**RE: Coors Pavilion Subdivision
9154 Coors Blvd
Grading Plan
Engineer's Stamp Date: 2/22/2017
Hydrology File: G11D069**

Re: G11D069 Coors Pavilion Subdivision – Master Grading and Drainage Plan

**RE: Coors Pavilion Subdivision
9154 Coors Blvd
Grading Plan
Engineer's Stamp Date: 1/31/2017
Hydrology File: G11D069**

**RE: Coors Pavilion Subdivision
9154 Coors Blvd
Grading Plan
Engineer's Stamp Date 01-04-2017 (File: G11D069)**

HYDROLOGIC DATA - PROPOSED

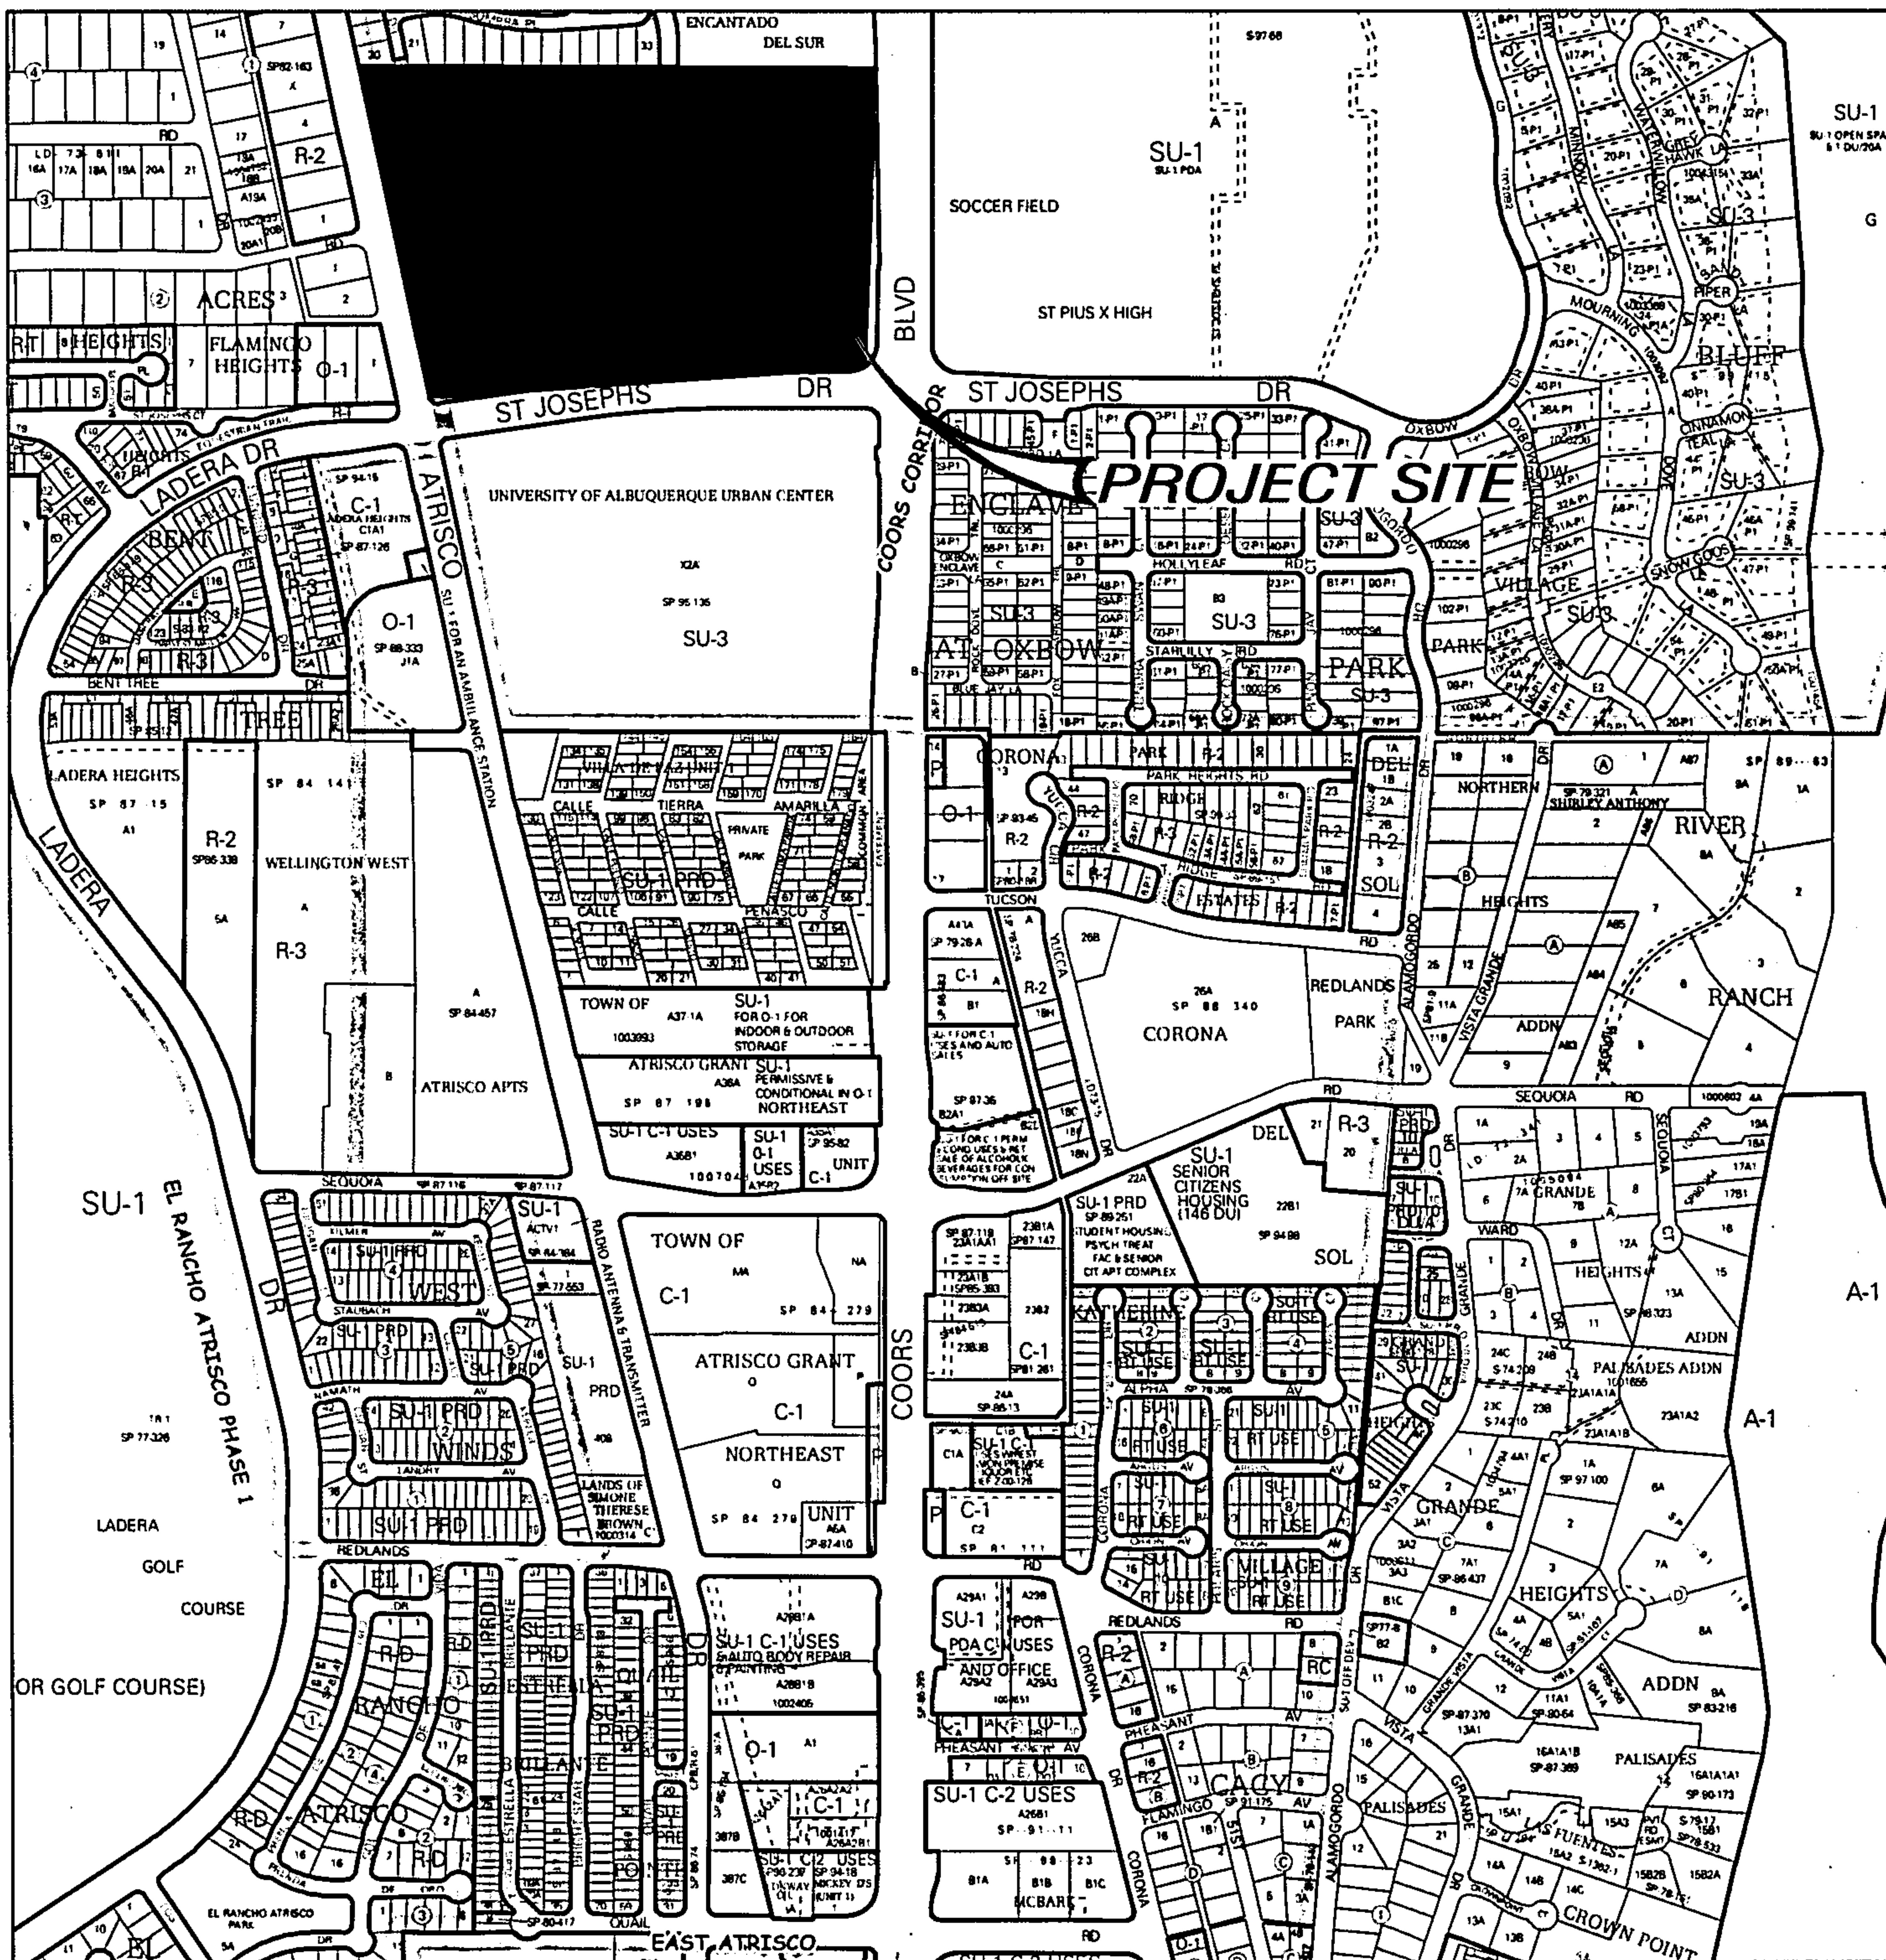
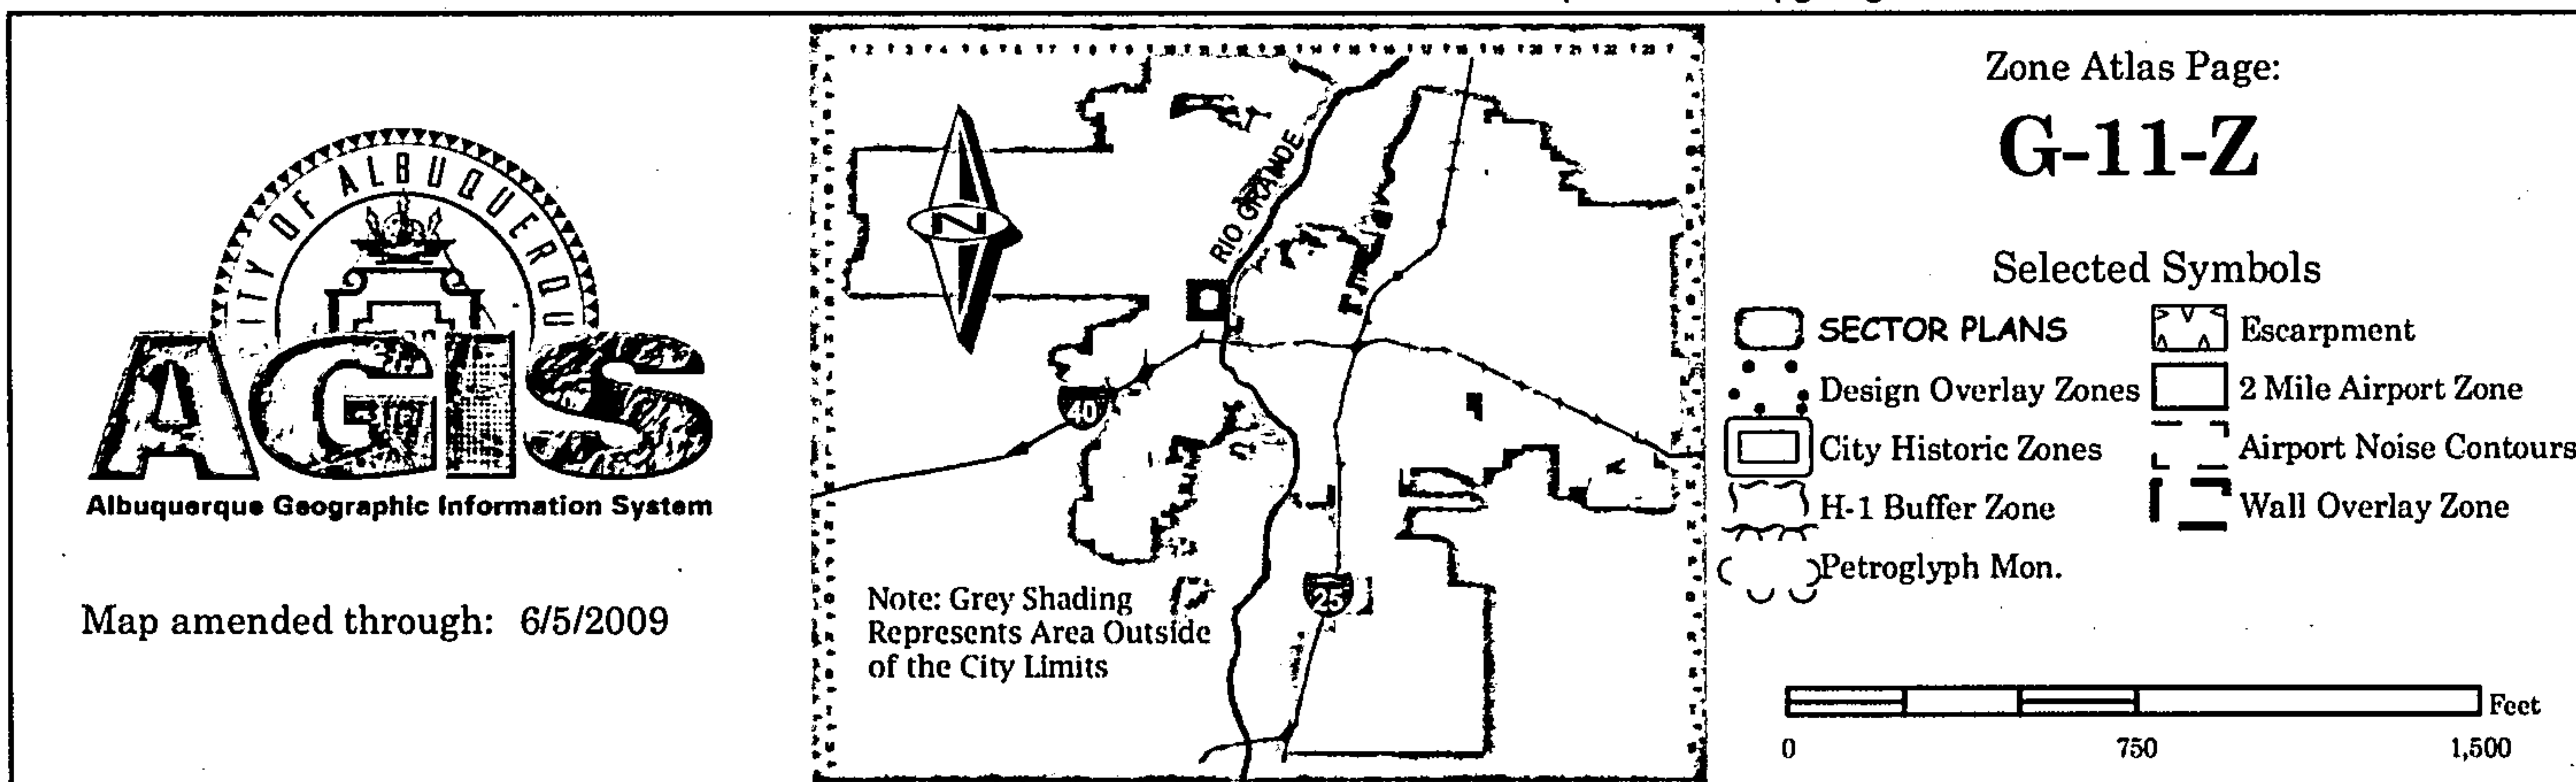
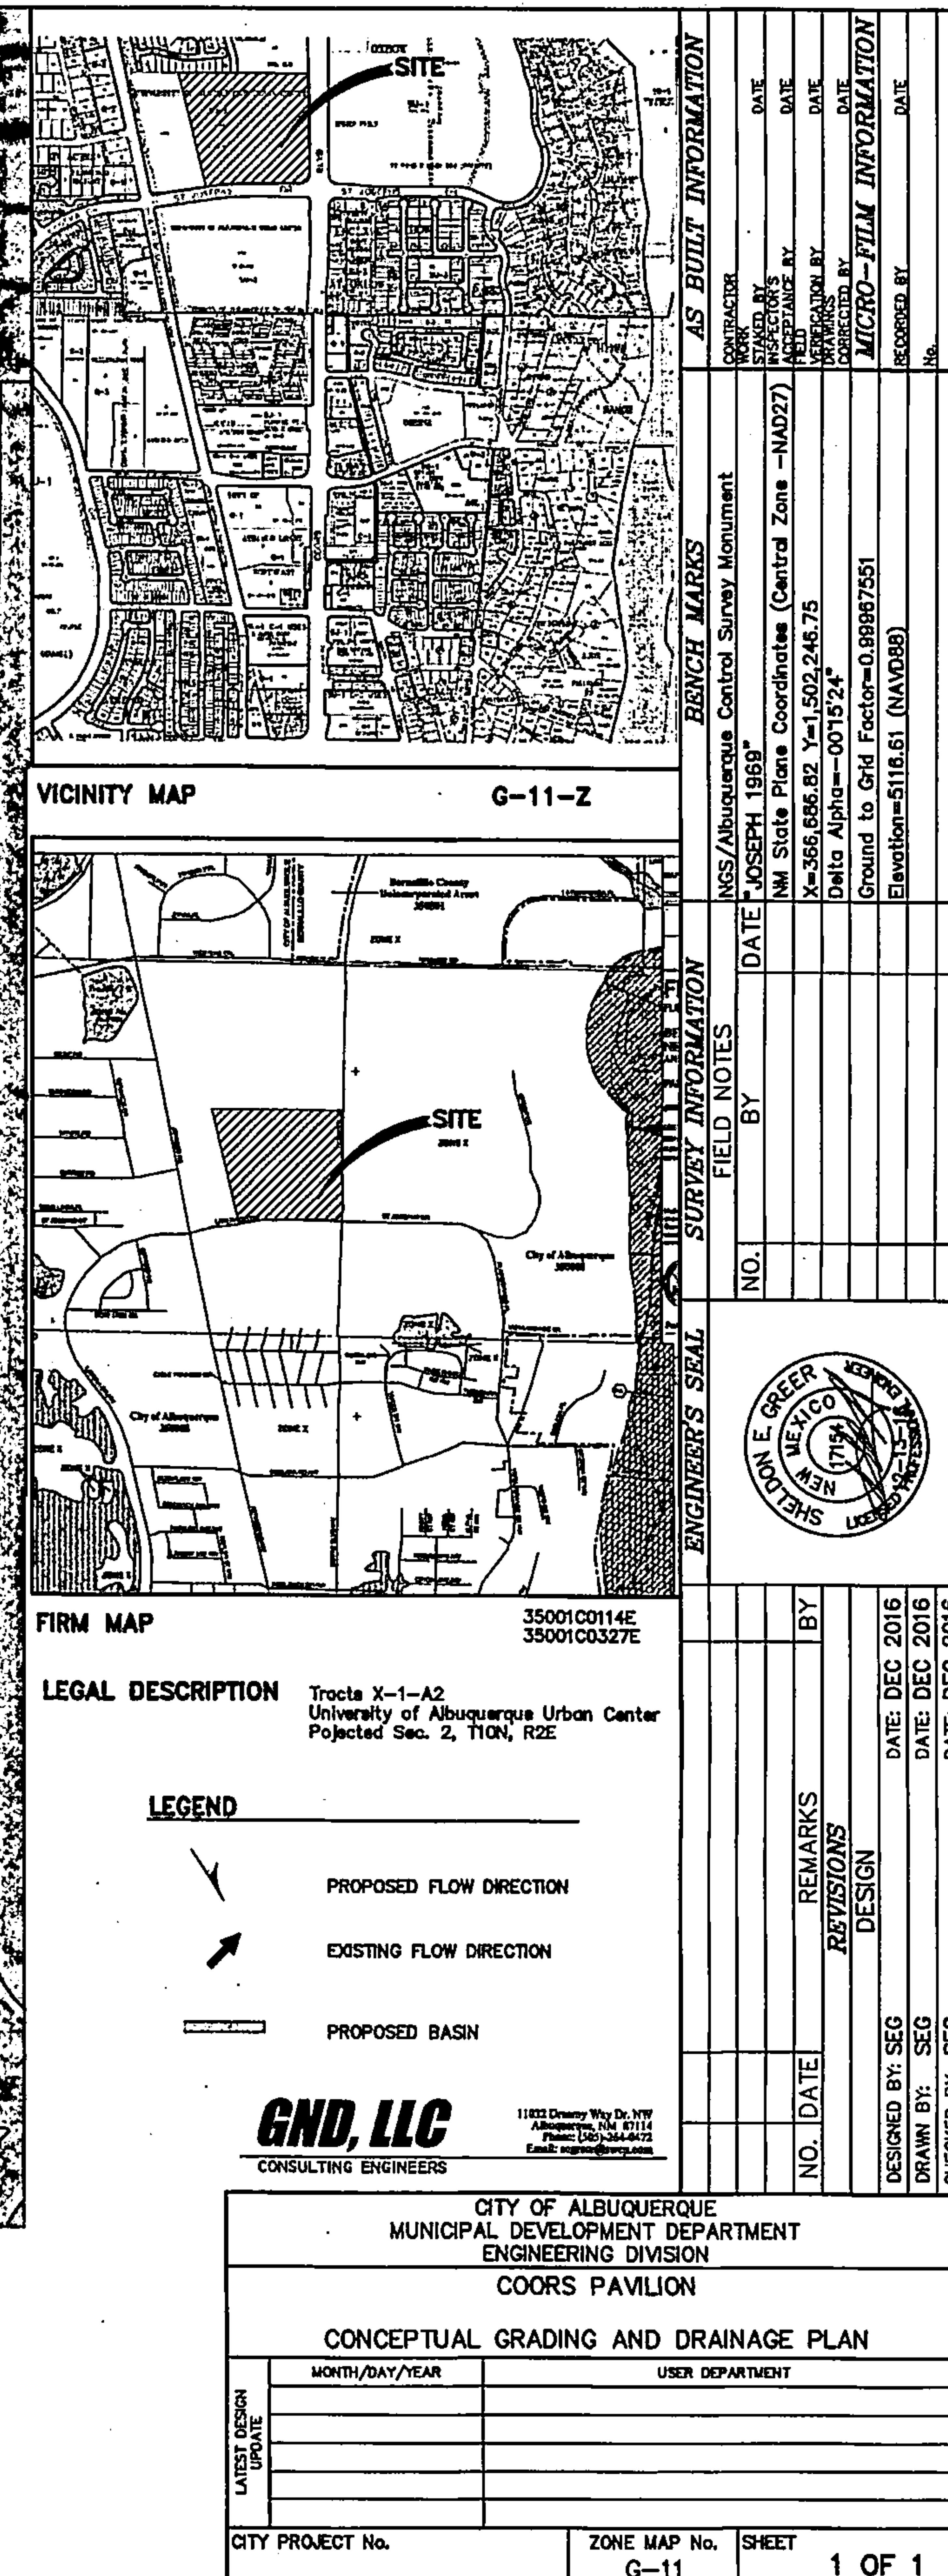
1. The AHYMO model routes discharge from Lot 7 into Lot 6, and along the alley to the north, then into the pond. However the drainage narrative and the drawing show Lot 7 as draining into Lot 8, then to the pond. The AHYMO model needs to reflect the drawing and narrative or visa-versa.

3. Waterblocks will be required where the alley joins Coors and St. Josephs to prevent excess flows from entering and contributing to the drainage area. These may be present already but are difficult to see; provide spot elevations and callouts to clarify.

4. Clarify contributions from adjoining lot X-1-A1. The AHYMO model appears to refer to this as "Church" with a contribution of 10.68 cfs and 0% impervious area. The drawing shows a contribution of 29.26 cfs. Is the existing pond being merged with the new one?

5. Proposed contours need to be added to the legend and to the lots. On this sheet no regrading appears to be taking place across the new lots.
6. The proposed water surface elevation of 5011.50 will back up into the alley and across a large portion of Lot 1. Is this desired?

7. First flush volume needs to be calculated and shown on this sheet, as well as how it will be retained in the pond beneath the invert of the outlet structure.
8. Additional detail is required on the outlet structure and its downstream effects. This includes inverts, velocities, grades, and HGL's.
9. Provide the input and output files for the AHYMO model.

1. The AHYMO model has been modified to reflect the described conditions.
2. The plan depicts the discharge from Lot7 and the adjacent drive being directed to a low point with curb openings.

3. The grade break elevations at the entrances are depicted on the plan and show the site discharge is prevented from entering the adjacent streets.
4. The Church drainage plan with retention pond has restricted the discharge from the site to historic rates. Therefore, the flow into the Coors Pavilion Pond has been modeled to accommodate flows entering the site from the retention pond overflow.

5. The legend has been corrected.
6. The alley will be cut into the existing ground. Prior to the development of the lots, the water surface will be contained within the alley. As the lots adjacent to the pond are developed, it is anticipated that the rim of the water surface will extend into parking areas. Pad elevations for these lots will be at least 1 foot above the water surface.

7. The first flush volumes and accommodations are depicted on the plan. The pond will have 3" below the outfall elevation for retention volume.
8. A detail of the modified Type D inlet has been included. The rating curve for the six pipe penetrations into the inlet is included in the AHYMO model. The downstream effects of the discharge from the site are minimal. There is a significant time differential in peak flow between the basins contributing to the storm drain system at the point of connection. Peak discharge from the existing basins contributing to the storm drain occurs at approximately 1.5 hours with a flow of 15.2 cfs in a 30" pipe. The capacity of the pipe flowing full is 18.95 cfs. Discharge from the
